BUFFALO RUN ACRES SUBDIVISION

CONSTRUCTION DOCUMENTS TAYLOR CITY, WEBER COUNTY, UTAH

BUFFALO RUN ACRES SUBDIVISION
CONSTRUCTION DOCUMENTS

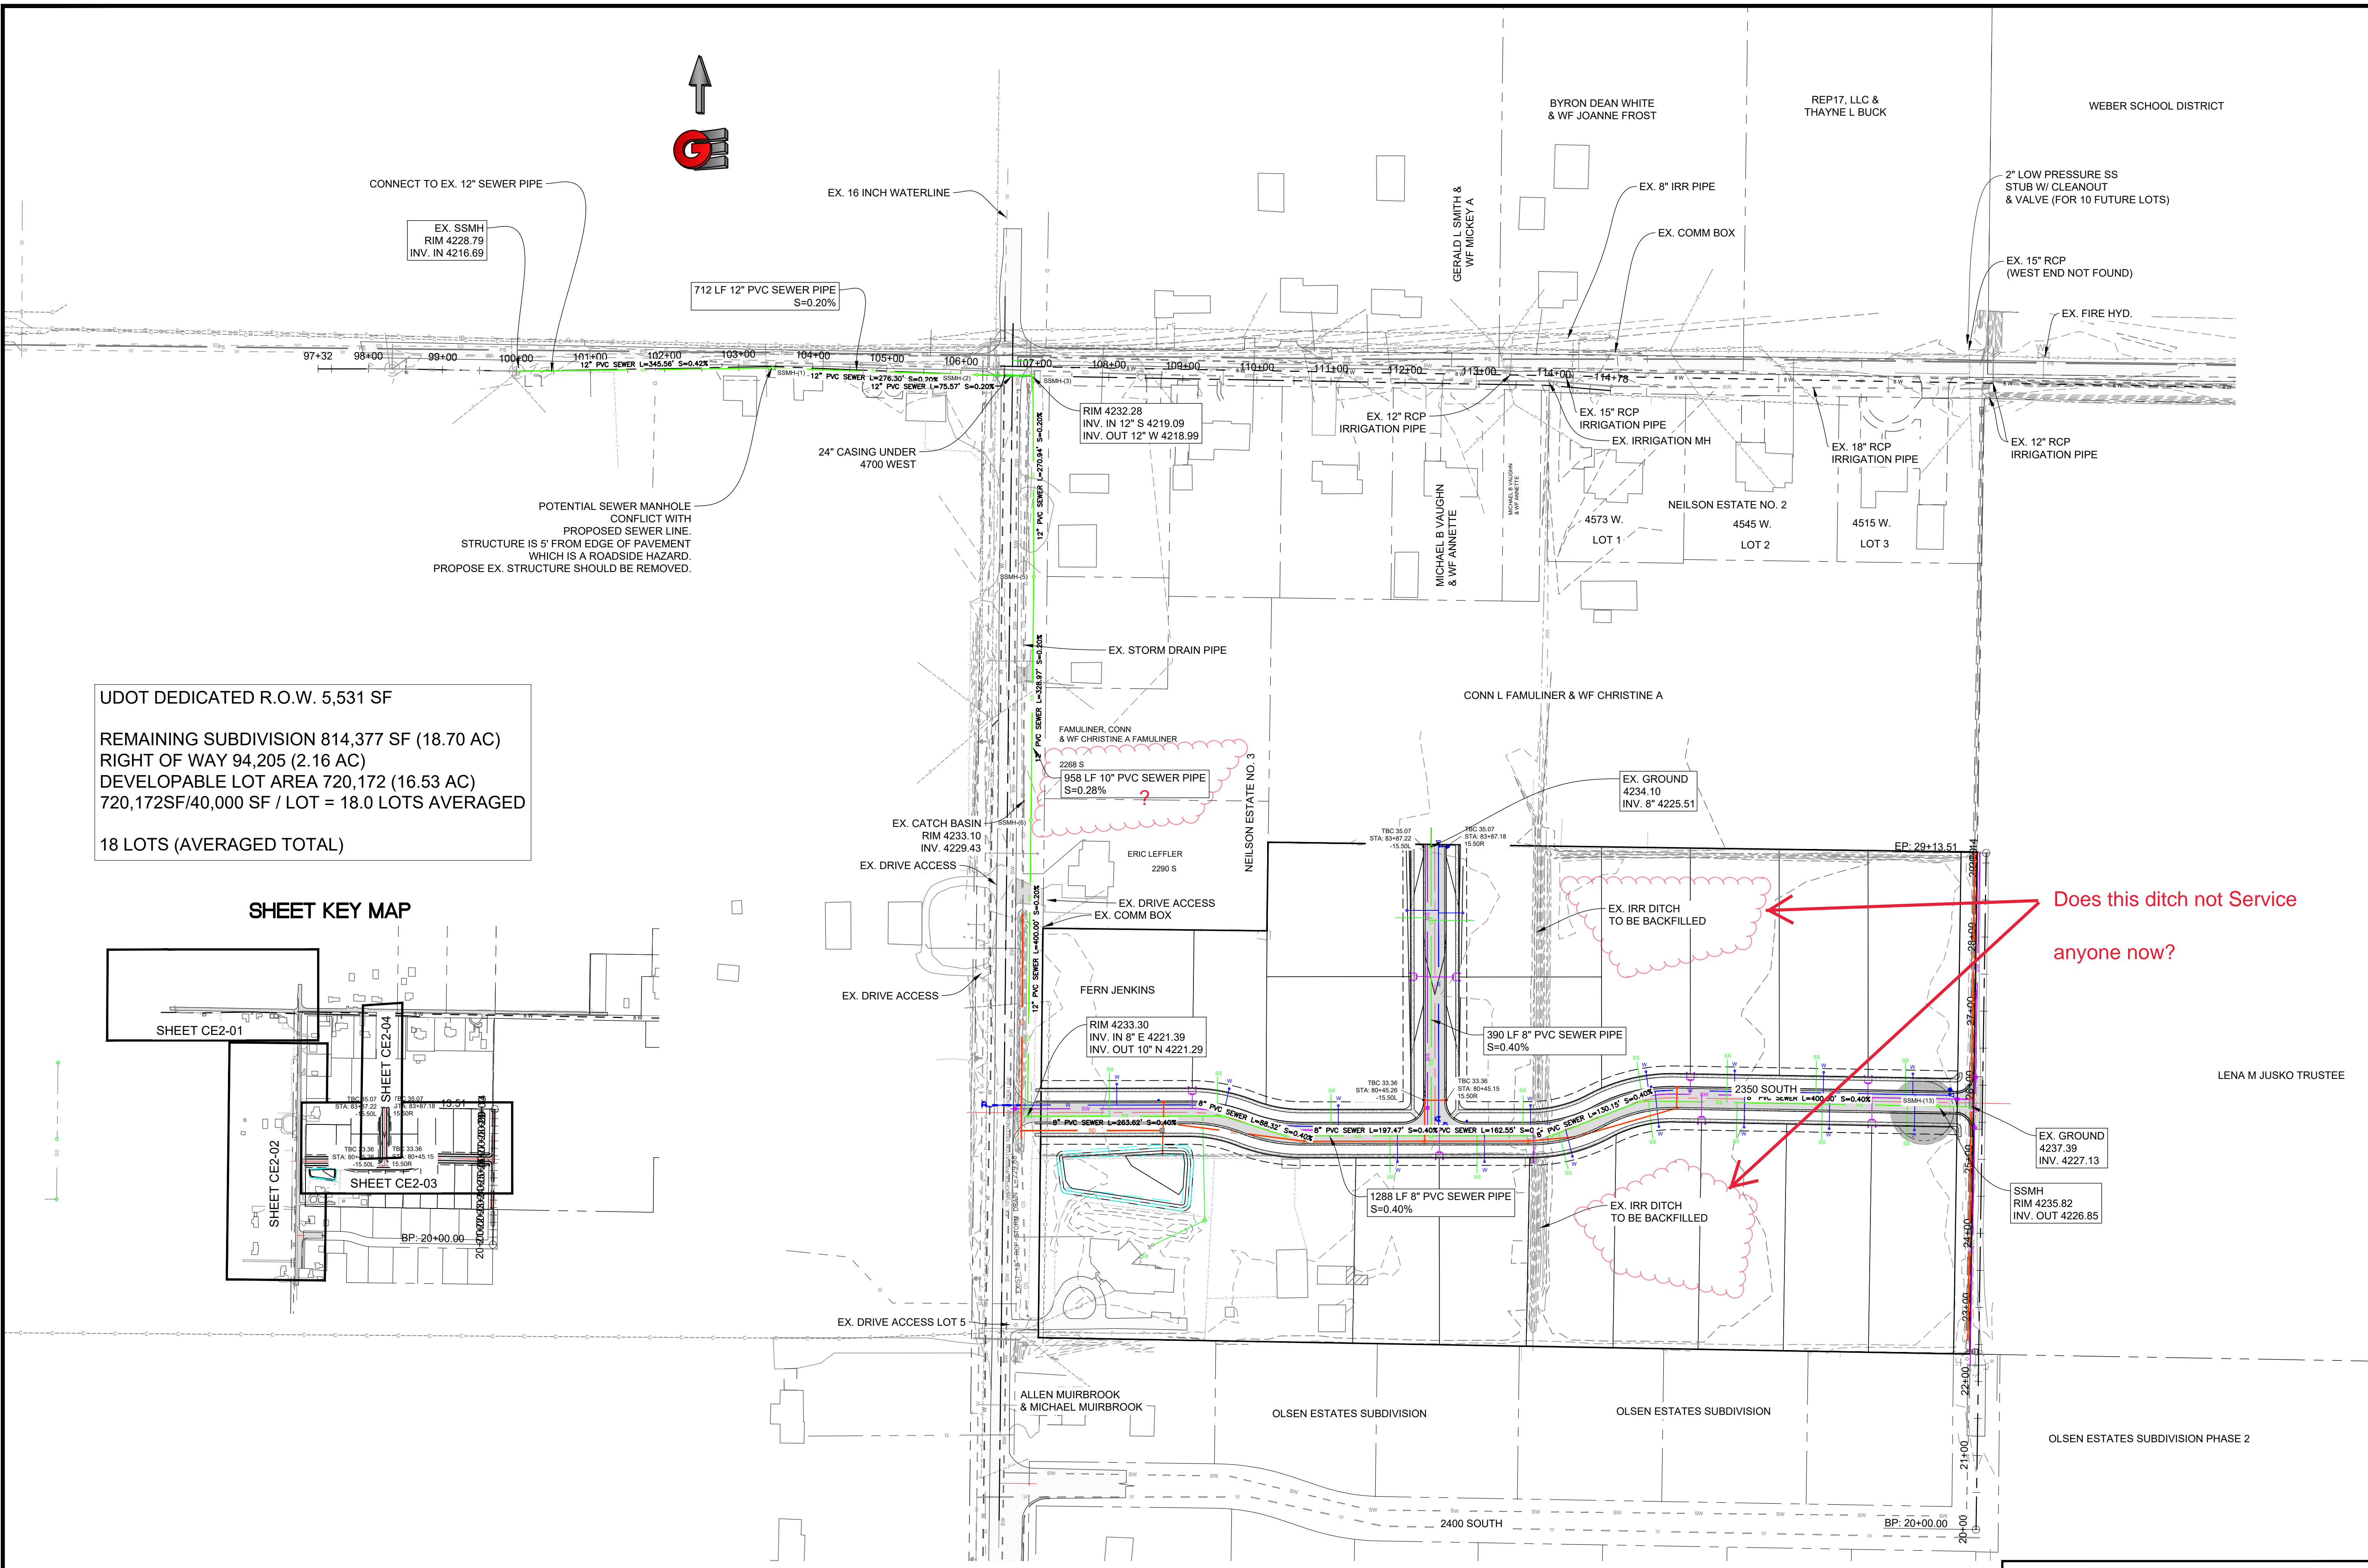
Please change to Central Weber
and Weber County

CE1-01

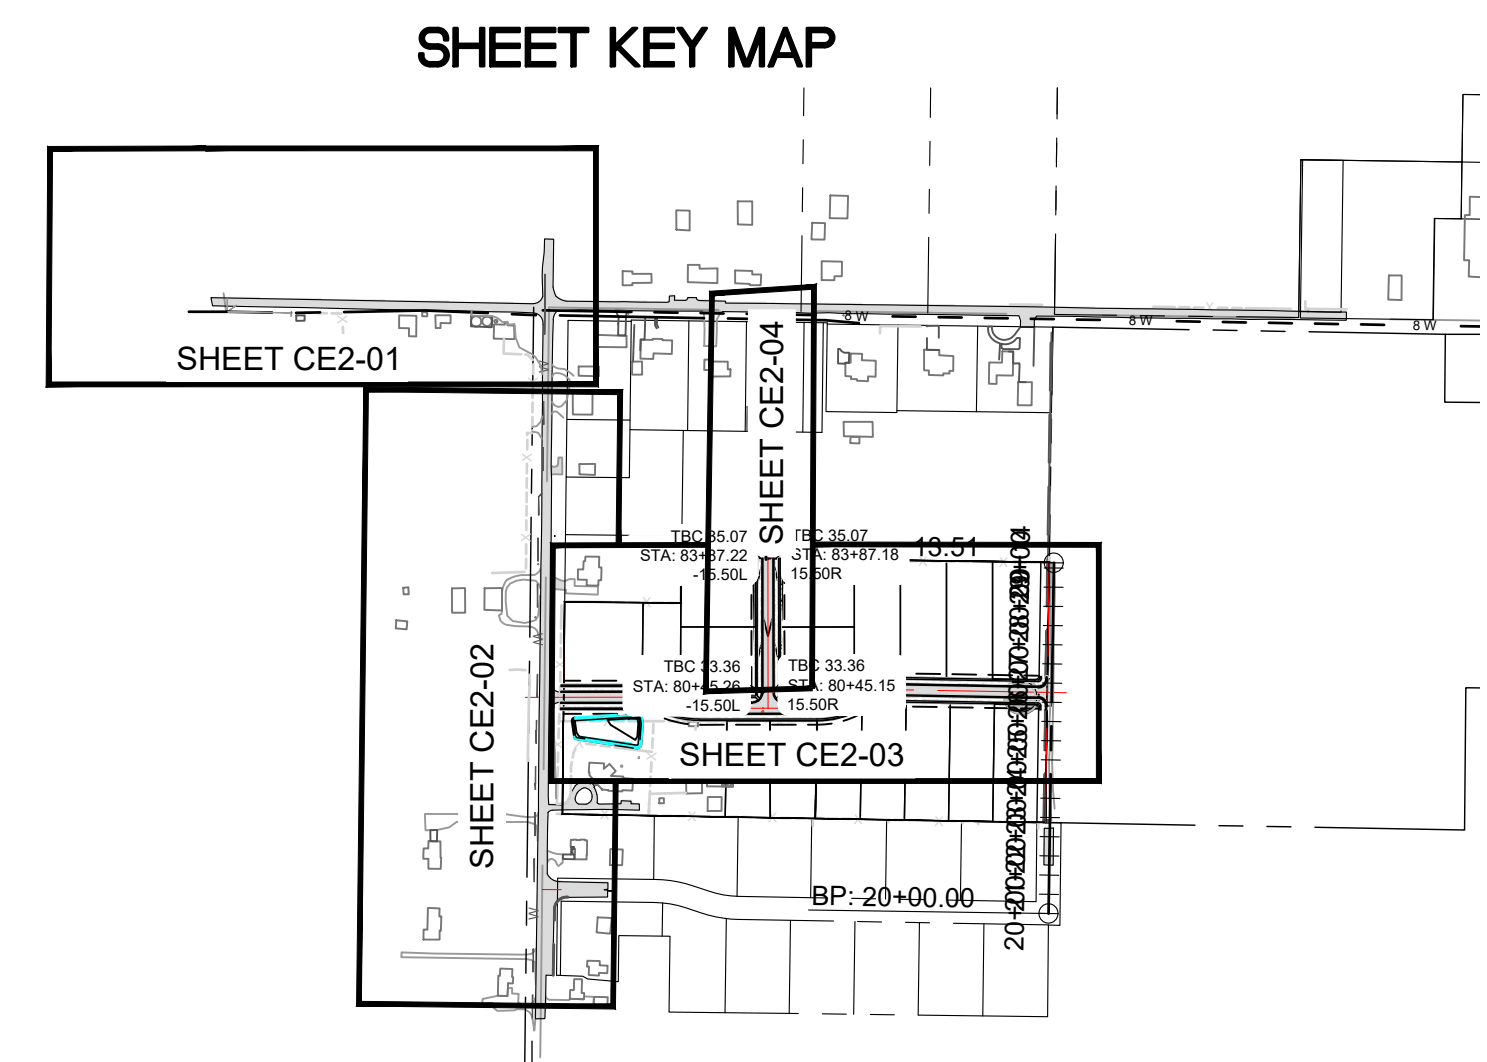
Does this ditch not Service anyone now?

CE2-01

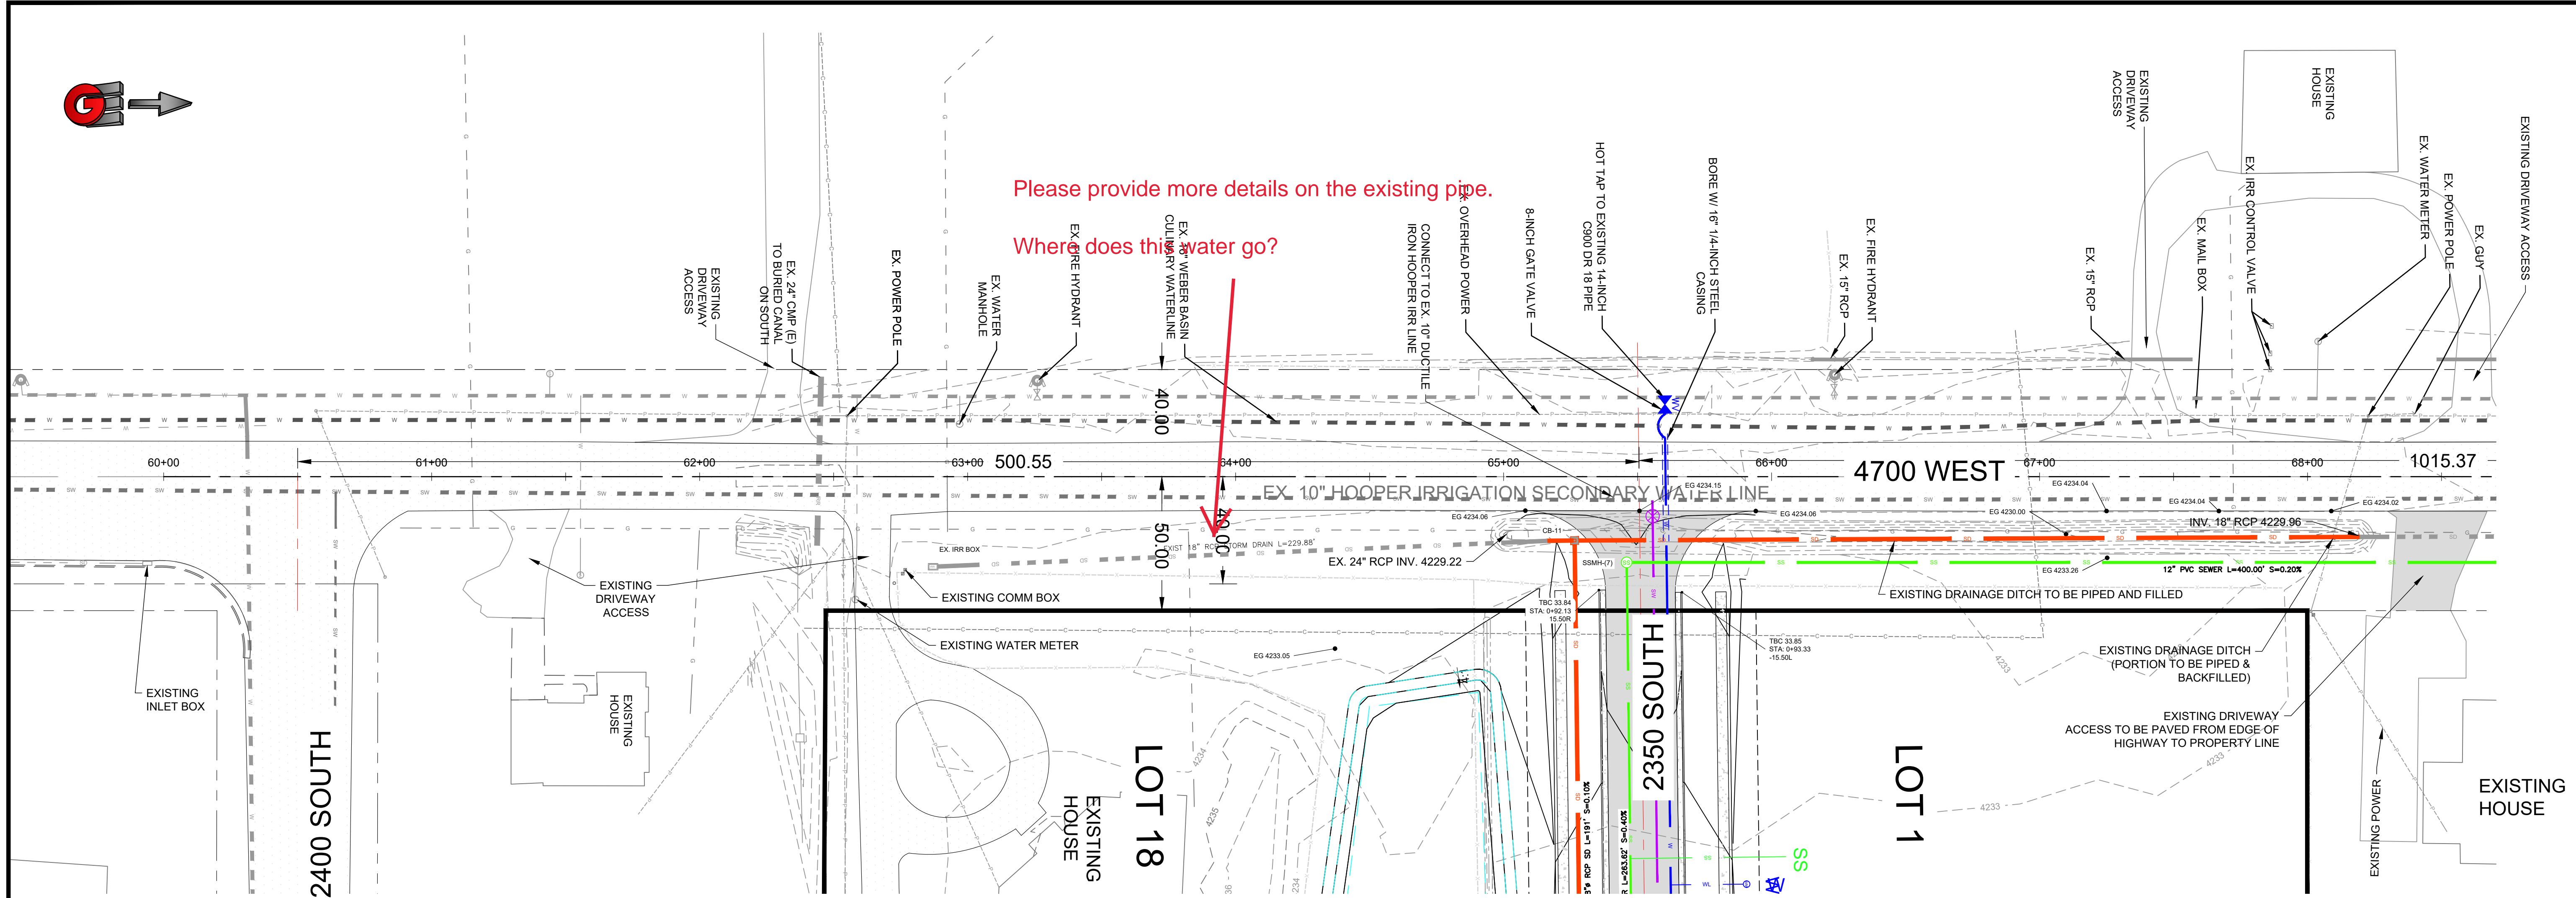
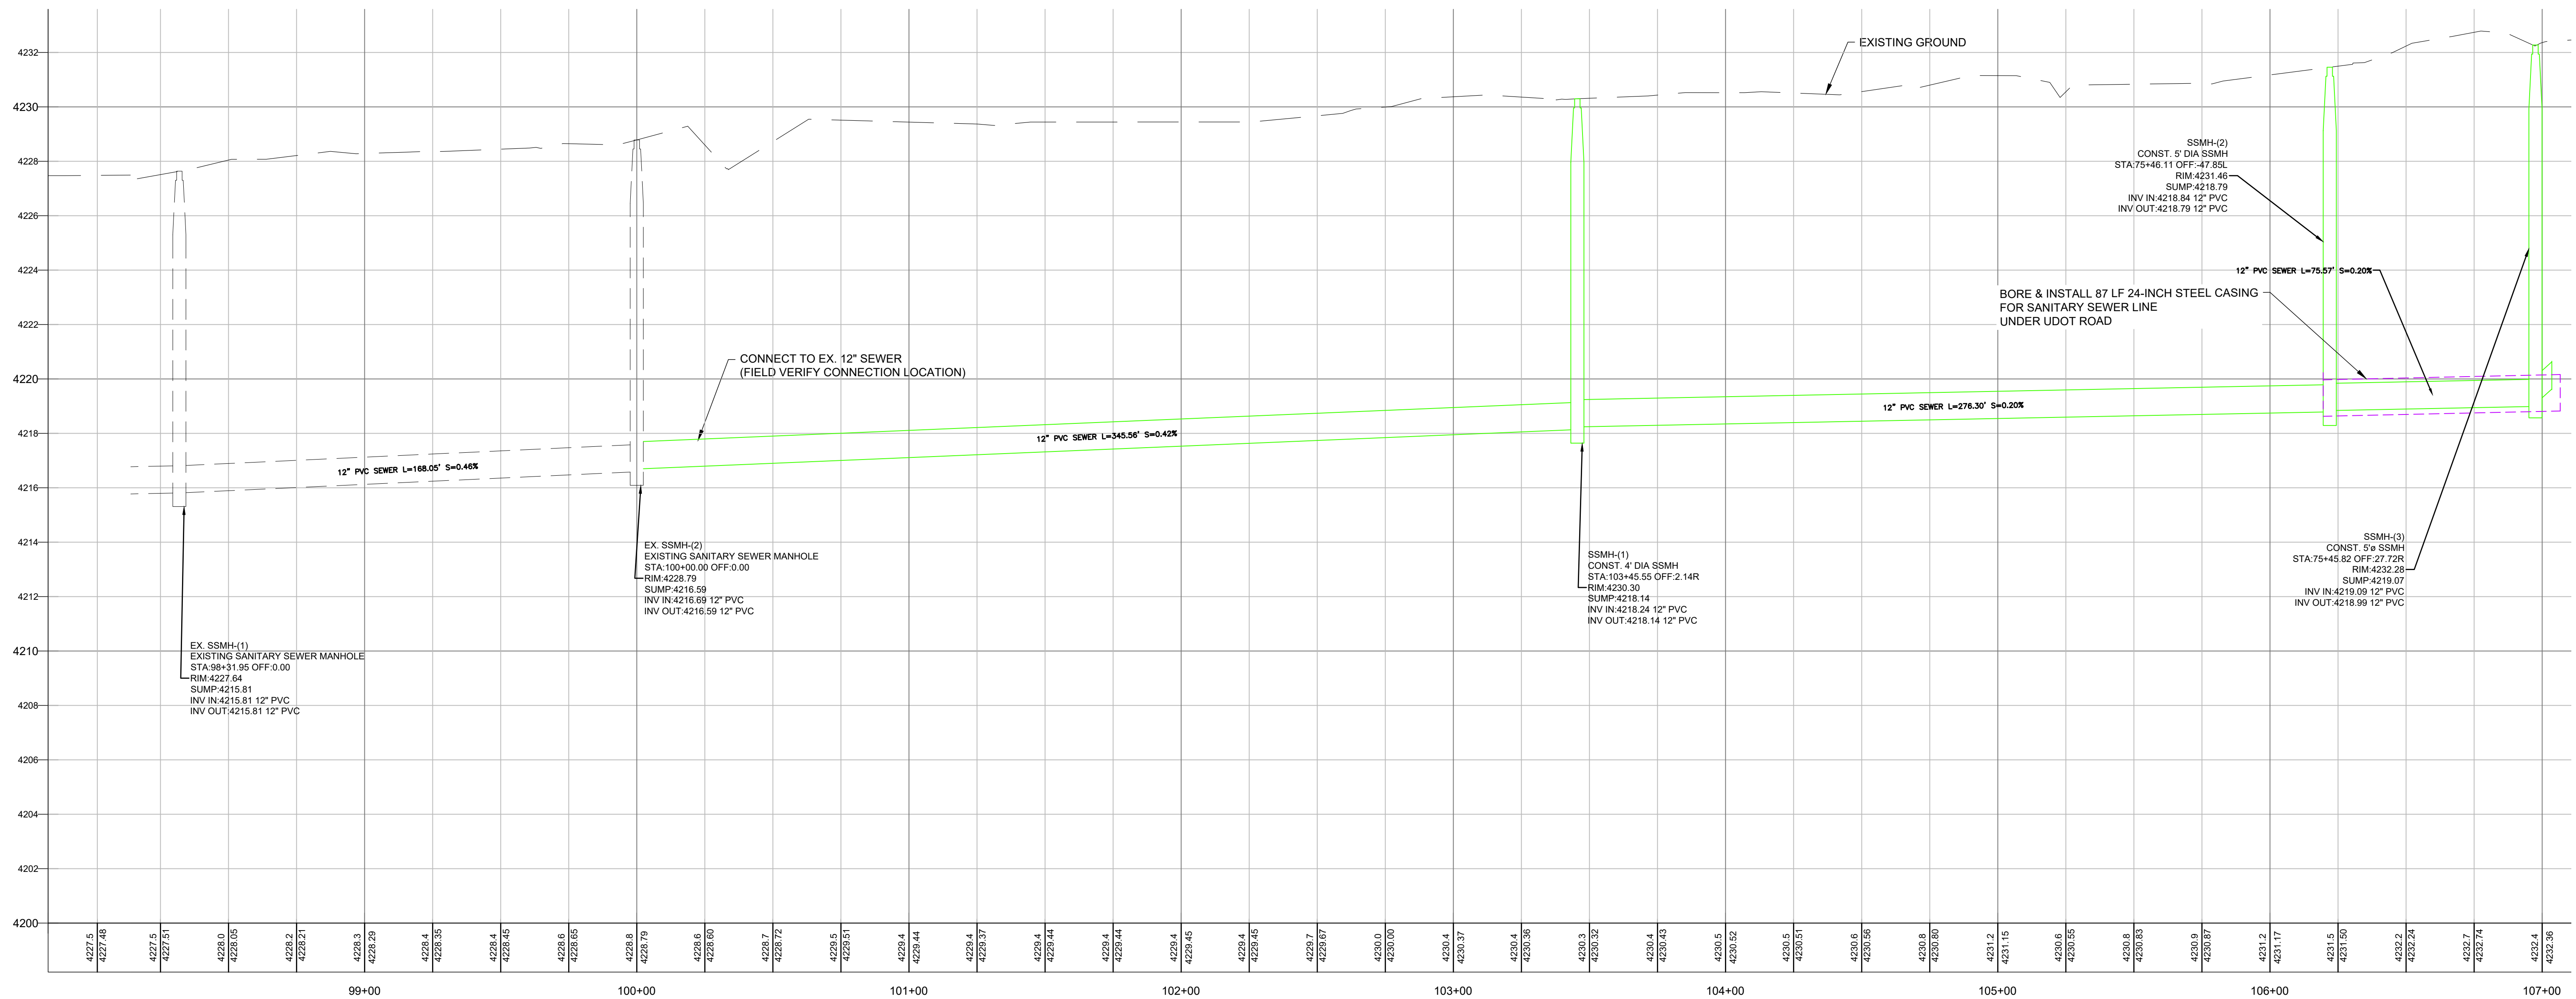
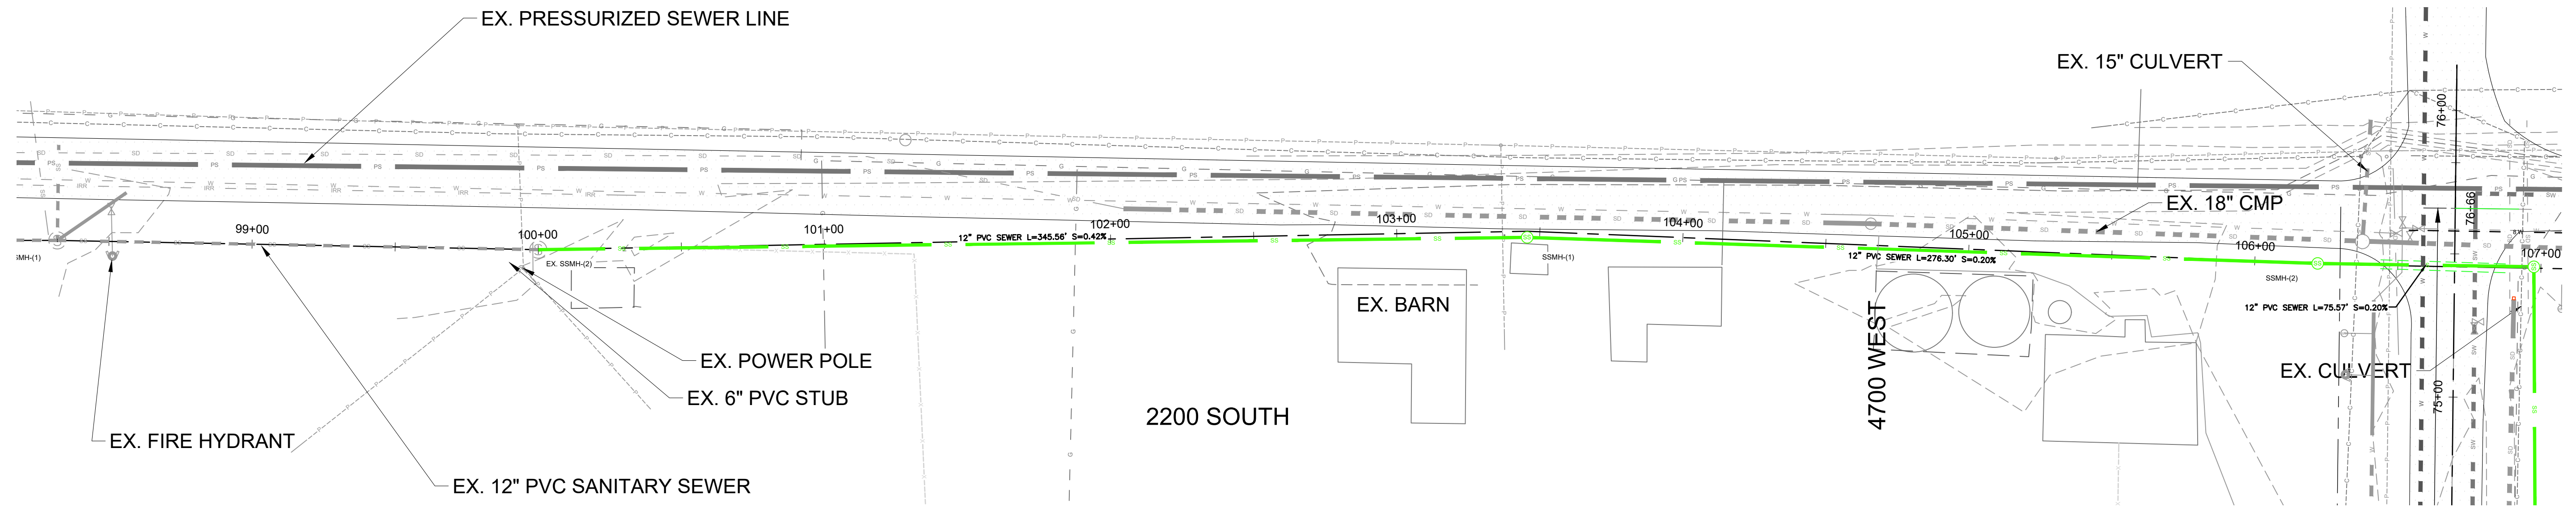
We will need you to install curb gutter and sidewalk on 4700 West.

Please get UDOT approval on the design. Please show that on the plans.
